Technical Information Bulletin

E261

PACCAR MX-13 EPA2017 Oil Thermostat and Filter Cap Replacement with Oil Survey

Service Bulletin

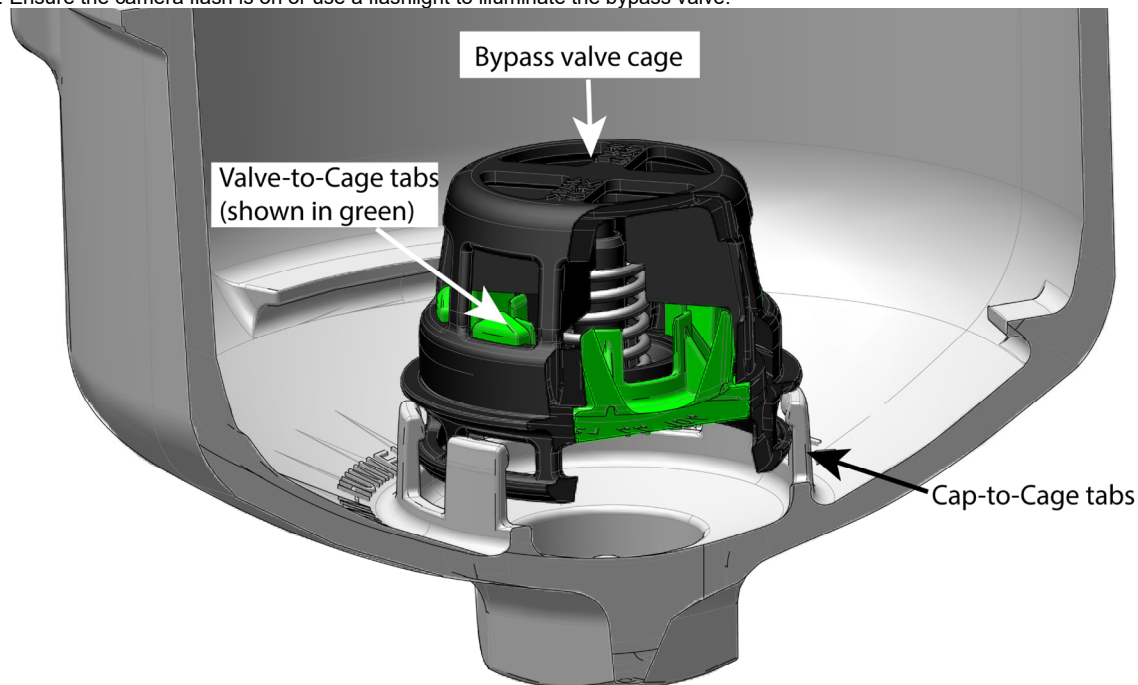
- On the Engine Oil Module, remove the filter cap.
- Remove the oil filter cartridge.
- Carefully, without damaging the filter, inspect the oil filter cartridge pleats for debris. If significant debris is found, take photos. The oil filter will have small amounts of debris as by design function of the oil filtration system.
 - A replacement oil filter is not included with this repair.
- Inspect the retaining tabs that hold the bypass valve cage to the filter cap and the tabs that hold the bypass valve to the cage. If any of them are broken, take clear photos.

- If broken bypass valve tabs are found or debris is found in the filter pleats, start a TCS365 case and await instructions from the VSC. Provide the following information in the case:
 - If tabs are broken
 - if significant debris was found in the filter pleats
 - attach photos
- Refer to the following procedure for the Lubricating Oil Thermostat replacement procedure. When the procedure is published in RMI, this bulletin will be updated to reference the procedure in RMI.

Removing thermostat, lubricating oil

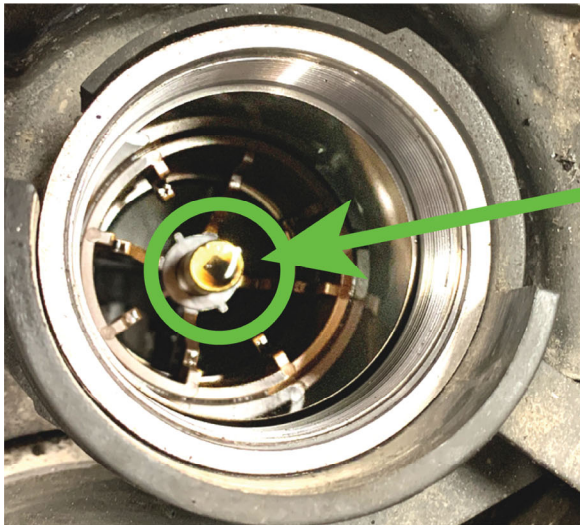
- Remove the spring from the oil module.
- Use pliers to grasp the thermostat, then remove the thermostat (2) and sleeve valve (3) together.

Removing the sleeve valve (3) without holding the thermostat may cause the thermostat to separate from the valve and drop into the oil cooler.

Grasp here with pliers

1. Fit the thermostat/ sleeve valve assembly and spring.
2. Fit the sealing plug (1) with a new sealing ring and tighten to the specified torque. (184 lb-ft, [250Nm])
